TRAFFIC ENGINEERING STUDY REVIEW of the TIS for the Sacramento Music Hall and Performing Arts Center Project

PRISM Engineering reviewed the Transportation Impact Study for the proposed Sacramento Music Hall and Performing Arts Center (prepared by Fehr & Peers), the comments made on the Mitigated Negative Declaration (MND), a letter from the City pertaining to the study.

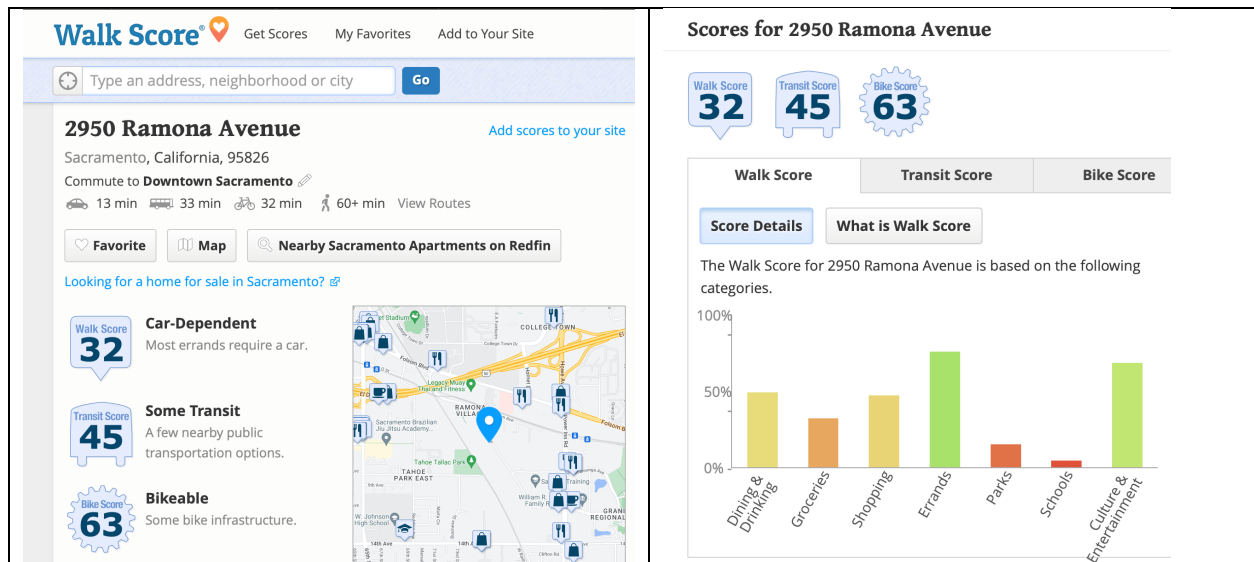
Many assumptions shown in the "Notes" section at the bottom of Table 3 are highly subjective and debatable. The first is the 65% arrival factor in peak hour assumption, that in an entertainment venue, that 35% of the patrons that drive would either come very early (outside of the hour time window of "peak hour") or an insignificant few stragglers come late. The result of this assumption is to lower the vehicle traffic in the peak hour analyses by an alarmingly high 35%. This level of reduction rivals and exceeds the sometimes controversial "pass-by" traffic reductions made in some traffic studies to account for shopping traffic that is already on the road and say, stops to shop at a store on the way home.

But it doesn't stop there, the equations in the Notes section of Table 3 also further discount the number of regular cars on the road (private vehicles) by an additional 25% to account for the highly optimistic

assumption that there will be a 25% mode split (people using UBER, Taxis, Buses, Light Rail, Walking or biking) which is too high based on the fact that there is no proof that this level of mode split efficiency is possible or has some precedent. It doesn't. In fact the typical mode split at the San Diego Padres baseball game for instance was only 5%, not 25%. The higher mode split happens in cities like San Francisco at a Giants game where this special event achieved a 34% transit mode split, and this with an extremely high venue attendance (38,000) and a highly developed transit bus and BART and light rail system in place throughout the city. It is not reasonable to assume that this will happen on Ramona Ave., etc.

Making the assumption that 35% of 2,219 people (777 people!) which includes those that will come by UBER, etc., are going to come early and say, eat at the local restaurant, is not even possible to do at the proposed 8,000 sq ft restaurant which can accommodate only a fraction of that amount of 777 people (6 times the restaurant capacity), is incorrect. The TIS says that the restaurant can only seat 60 people¹ inside and 70 outside for a total of 130 people only, much less (1/6) than 777 people that are assumed to come early (the 35% discounted factor shown in Table 3 for all calculations). This assumption vastly

reduced the project’s real traffic impacts, and if it were true, would mean that the project venue parking lot would nearly fill up even before the show started (777 people, approximately 2.3 per car, is 338 cars, or getting close to the capacity of the 440 spaces on site well before the show even starts).

My conclusion is that the 35% reduction assumptions shown in Table 3 are therefore extremely optimistic and unrealistic, based on typical mode split results measured in the real world at entertainment venues, especially in industrial areas where there is no residential density (no high-rise or skyscraper dwelling units), and no ubiquitous transit in place (light rail or bus routes, let alone subways or BART, etc.).

Figure 7 is shown here for convenience. The source is page 22 of the TIS for this project.

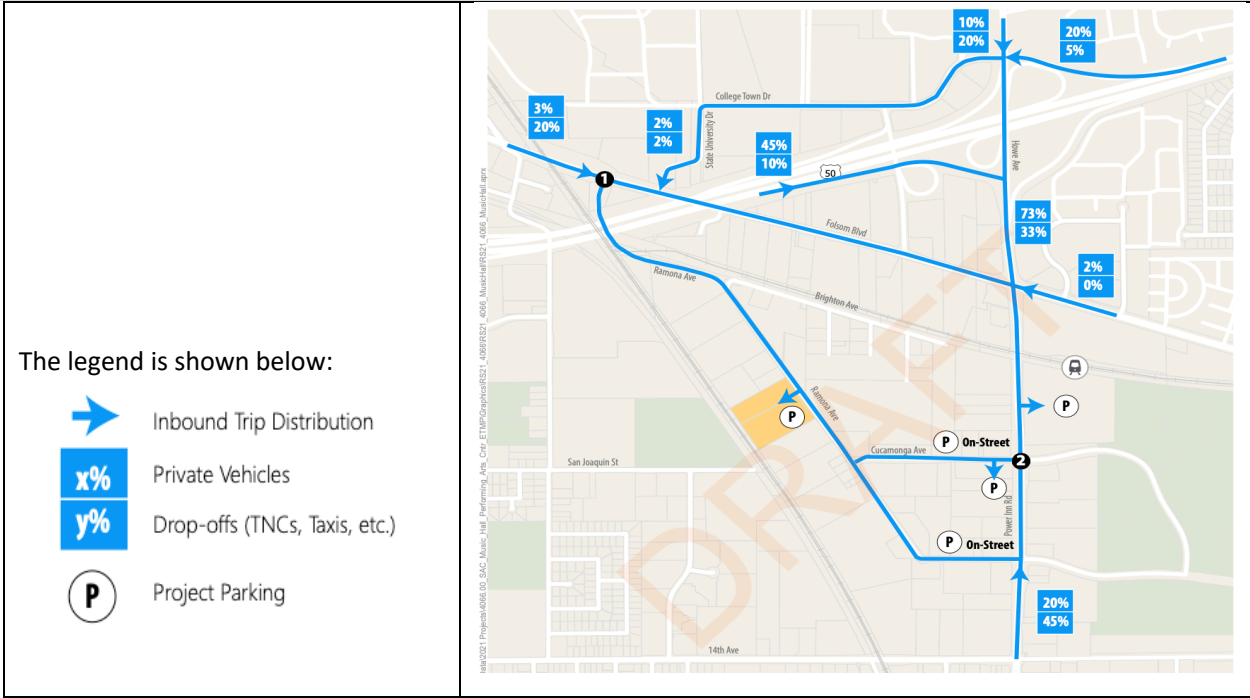
The figure does not show the specific shuttle component. The report reads that there would be only ONE bus and that it would make 4 round trips to move people parked in remote lots. In fact there are issues as to how effective a large shuttle bus would be unless there are several shuttles working simultaneously (the wait times would be very high, especially if you have to wait two or three buses which could take 30-45 minutes to do), and even so, security issues and unknowns remain with the remote parked vehicles themselves. There is also the issue of “advance notice” so that patrons could know which lot had spaces available to try and park there. Would parking spaces be available? How would they know in advance if the project site’s more preferred parking lot is full or not, that they might drive all the way in and park there instead? Why would anyone choose a remote lot with the possibility that the main lot next to the building has spaces available? Do they need to drive all the way there only to be turned away? Who would inform the patrons which lot to go to instead for parking?

The TIS showed only 15% of the UBER / Taxi traffic coming from the US 50 freeway, which seems very low. A very high 45% was showing coming from the south on Power Inn Rd., but only 20% coming from the north areas on Howe Ave. / Power Inn Rd. This distribution pattern seems very low for the freeway, and very high to assume that most (65%) of the UBER / Taxi traffic would be using Power Inn Rd. Why are so many UBERS using Power Inn Rd, instead of coming from more remote locations such as the adjacent Watt Ave. and traveling via US 50 freeway to get to Power Inn Rd.? Or even from East Sacramento via US 50 or Folsom Blvd.? My conclusion is that the TIS assumptions for Trip Distribution do not make logical sense, especially when the TIS shows private cars coming to the venue via US 50 being 65% of that total (indicating that patrons mostly live far enough away to need to take the freeway). This compares to only 15% of customers using UBER or Taxis would come from far away. How is this known? The TIS made comparisons to the Golden 1 Center, a major sports venue, but this does not compare with the much smaller venue considered in this study. In downtown Sacramento, there is a very high population of employees who would rather take an UBER and avoid the hassles of trying to find a parking space and pay a high fee for a parking garage. There are obvious reasons why an UBER choice is preferred by the high number of UBER customers in that area, making the trip short (less than 3 miles) but this has a lot to do with customer choice. A person in Folsom or Roseville far away has just as much of a desire to attend a Kings game, as someone who works in a high rise in downtown Sacramento. The person who lives in Folsom or Roseville is also not a likely UBER customer because and UBER Black trip for these 20 miles will cost up to \$121. A private vehicle that can carry 4 to 5 passengers will be much cheaper at cost of gas being maybe \$5 and adding in \$20 parking and the convenience of no waiting for an UBER, makes it a much more attractive option. For a short 3 mile UBER ride from say, West Sacramento to the Golden 1 Center, this is a \$18 trip for an UBER Black, a very attractive option to otherwise finding AND paying for parking at \$20-45. So the comparison made in the TIS as to what happens with UBER sales at the Golden 1 Center is really not relevant in any way considering the economic and logistical dynamics there, and comparing to the entirely different situation that would happen on Power Inn Rd.

It is my opinion that these two modes (private car use, UBER/Taxi use) should have the same or very similar use of the US 50 freeway given the very regional nature of this venue and customer base and its suburban location, attracting customers from remote locations (due to its regional fan base), as well as according to the TIS trip distribution assumptions made for private cars/customers/fans. It is not logical to assume UBER trips are mostly short and within a 3 mile radius when the average UBER trip length is about 7 miles.
